**APPLICATION NO. A/YL-NSW/373 FOR PERMISSION
UNDER SECTION 16 OF THE TOWN PLANNING ORDINANCE**

FURTHER INFORMATION SUBMISSION

Section 16 Application for Temporary Warehouse (Excluding Dangerous Goods Godown) with Ancillary Facilities and Associated Filling of Land for a Period of 3 Years at Various Lots in D.D. 104 and Adjoining Government Land, Pok Wai, Yuen Long

Response to Departmental Comments Table

Annex 1 : Swept Path Analysis

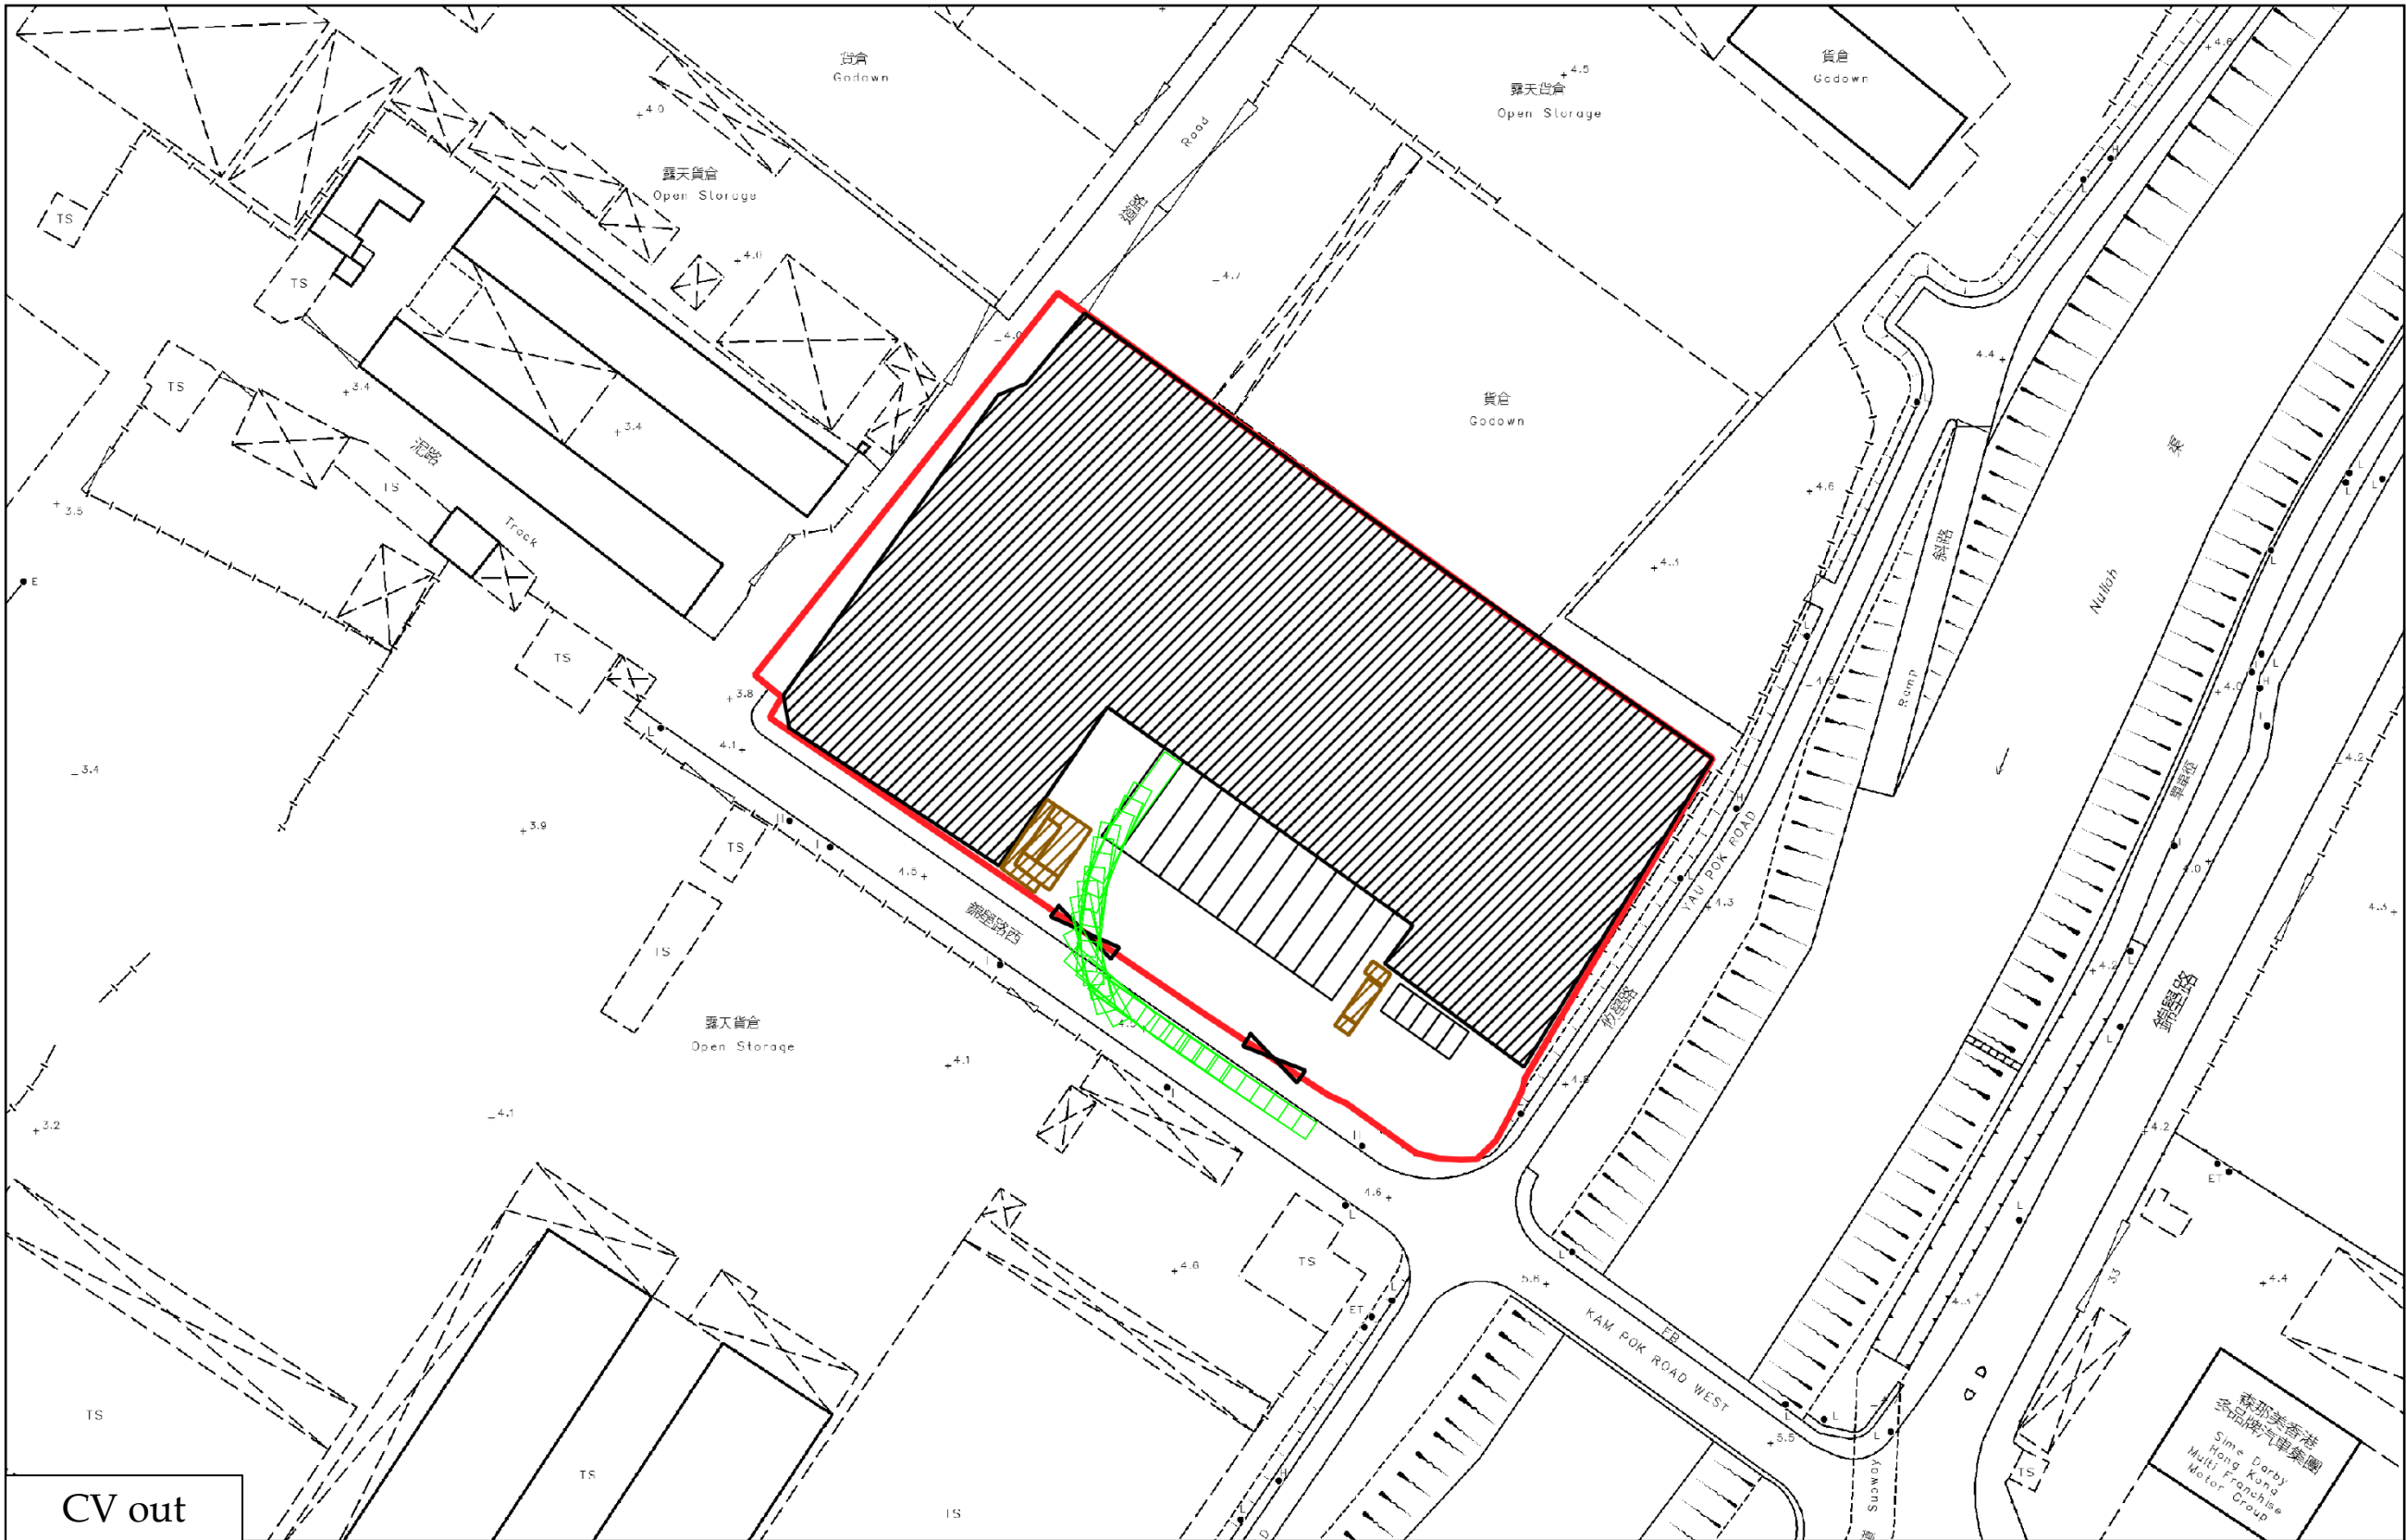
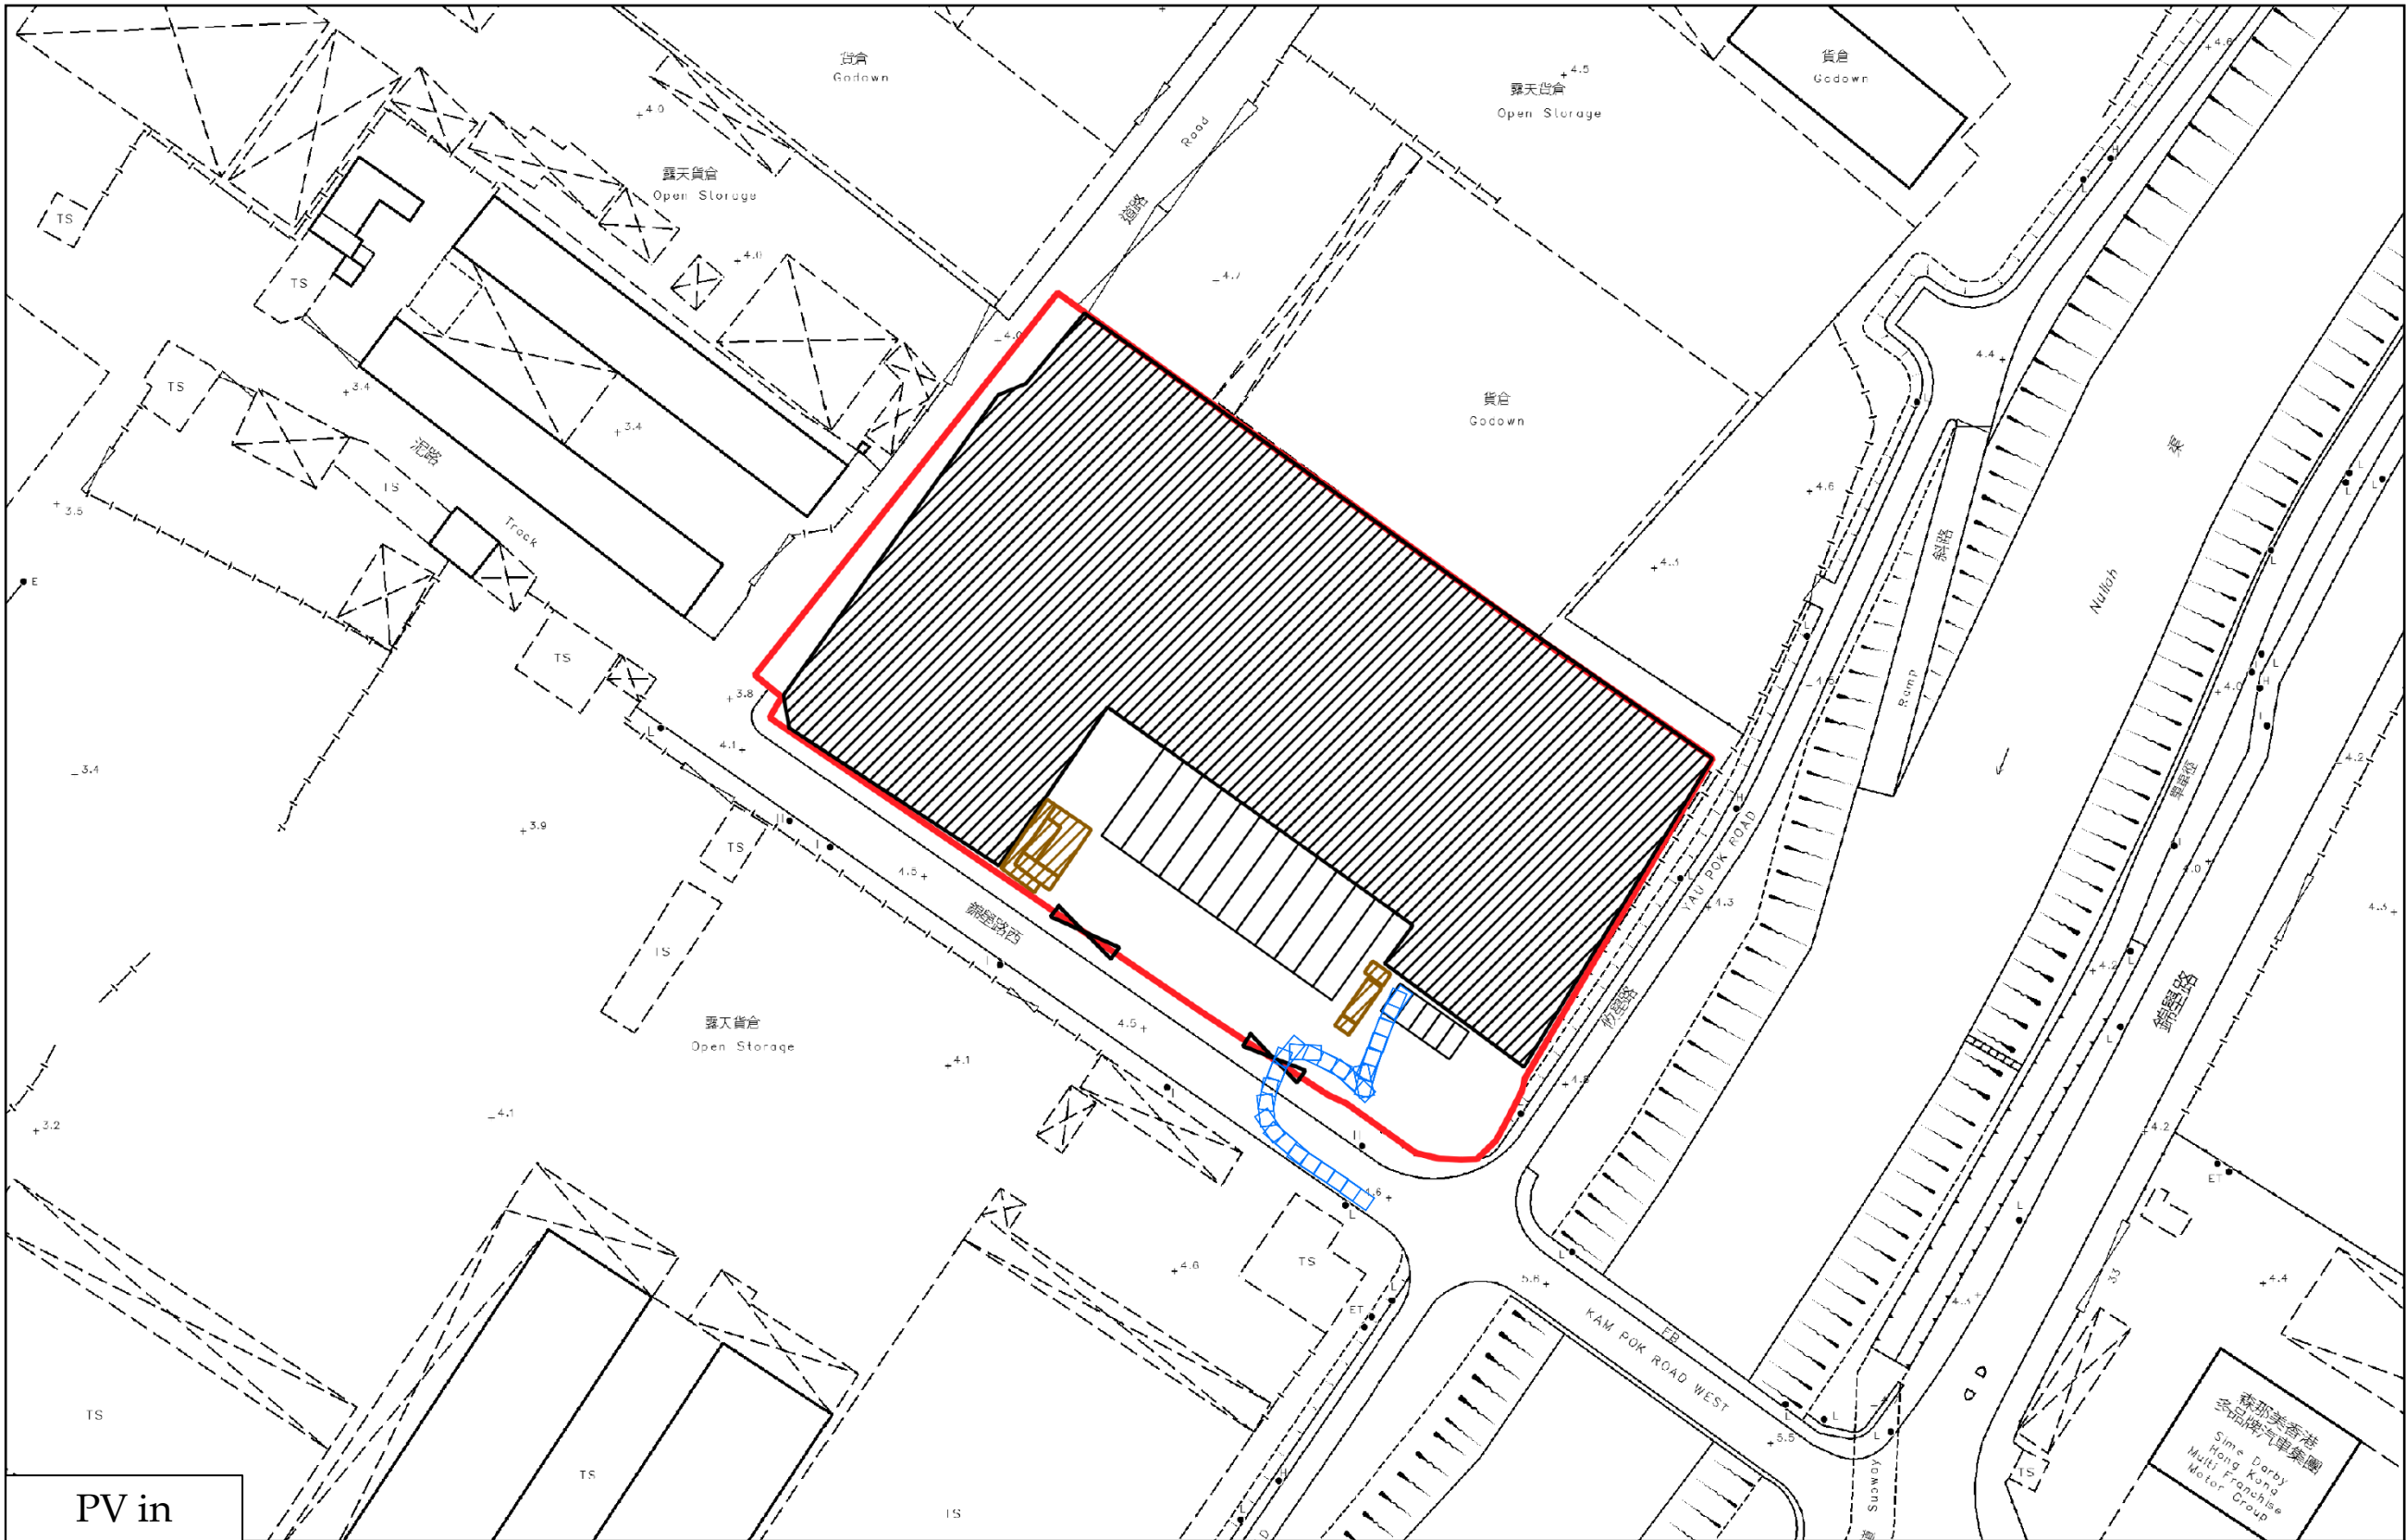
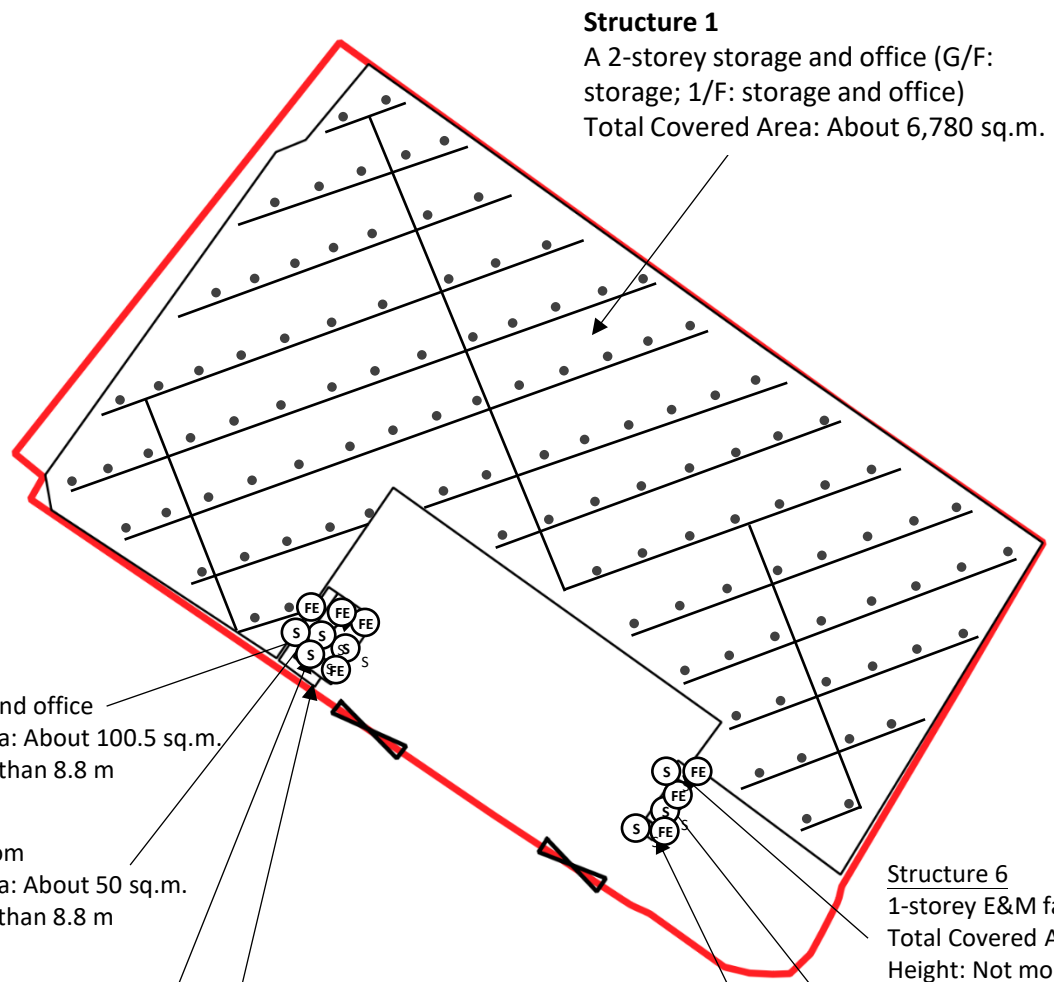
For Annex 1 - It is noted that the swept path encroaches upon the footpath of Kam Pok Road East. Please review; and	The swept path analysis has been revised accordingly. Please refer to Annex 1 .																																																				
	For Annex 2 - Please clarify whether the 9.7m wide ingress/egress will be used by 16m long container vehicle. If affirmative, please supplement the swept path analysis.	The 9.7m wide ingress/egress will be solely used by private vehicle but not the 16m long container vehicle.

Annex 4 : Landscape Mitigation Measures

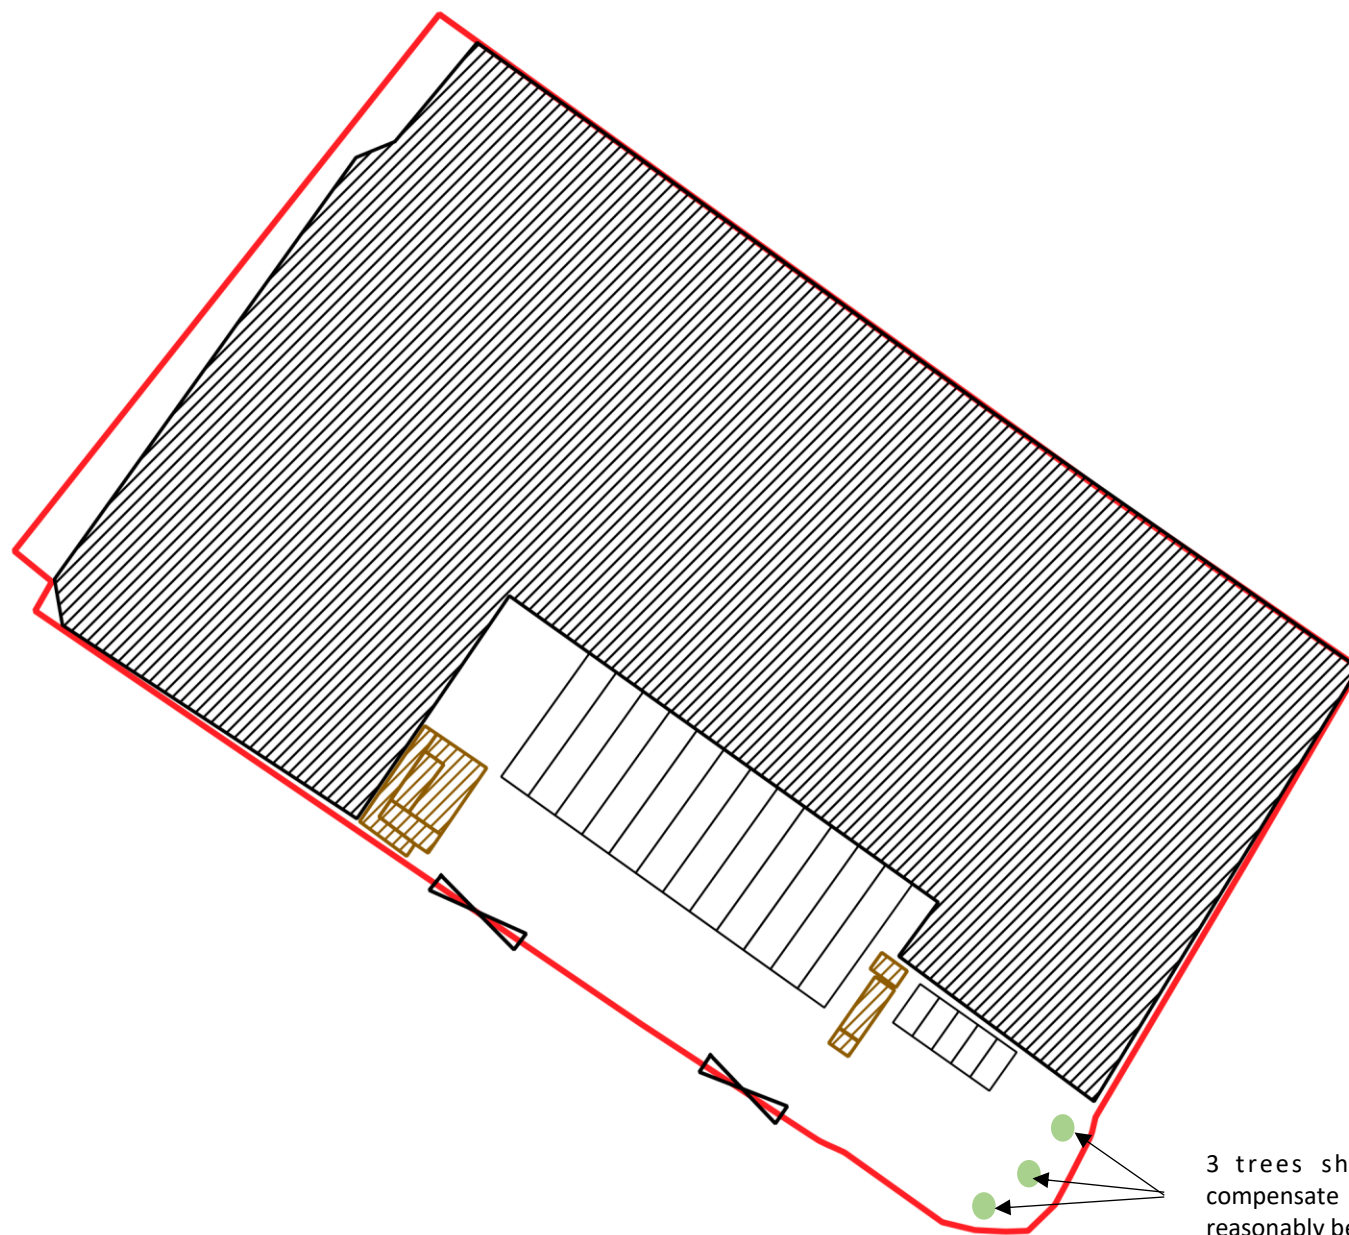
如果擬建構築物須符合《建築物條例》（第 123 章）的規定，詳細的消防安全要求將在收到正式提交的一般建築圖則後制定。	
3.	<i>Comments from Planning Department received dated 11 August 2026 (Subject Officer: Ms. Mandy KWOK, Tel: 3565 3953)</i>	
a	According to the Applicant's Submission, the applicant stated in Para 3.9.1 of the Planning Statement that "No trees are identified within the current site". However, with reference to DPO's site photos taken on 23.7.2026 and her Site inspection on 29.7.2026, some trees were found at the northwestern and southeastern of the Site. With the reference to Figure 3 and 7 (Land Status Plan and Proposed Land Filling Plan), the southeastern portion of the Site (mainly government land) was proposed to be filled and existing trees would be affected.	The southeastern portion of the Site is Government land, resumed in 1999 and remaining vacant and unused since. Existing trees in this area are generally small, immature and naturally regenerated, and by their observed size, condition and form have limited amenity and landscape value. It is acknowledged that the proposed land-filling may affect some of these trees on Government land. All trees on the private lot lie outside the site boundary. Any tree-felling would only be confined to Government land. The vegetation within the concerned government land is mainly of grasses and self-sown shrubs/trees of low arboricultural value, and does not include registered Old and Valuable Trees or trees designated for preservation under the lease. Where practicable, trees outside the essential works area will be retained and protected during construction and operation. For trees that cannot reasonably be retained, appropriate mitigation measures, including compensatory planting of 3 trees and landscape enhancement within the Site, will be implemented. Please refer to Annex 3.

3 trees shall be planted to
compensate for those that cannot
reasonably be retained
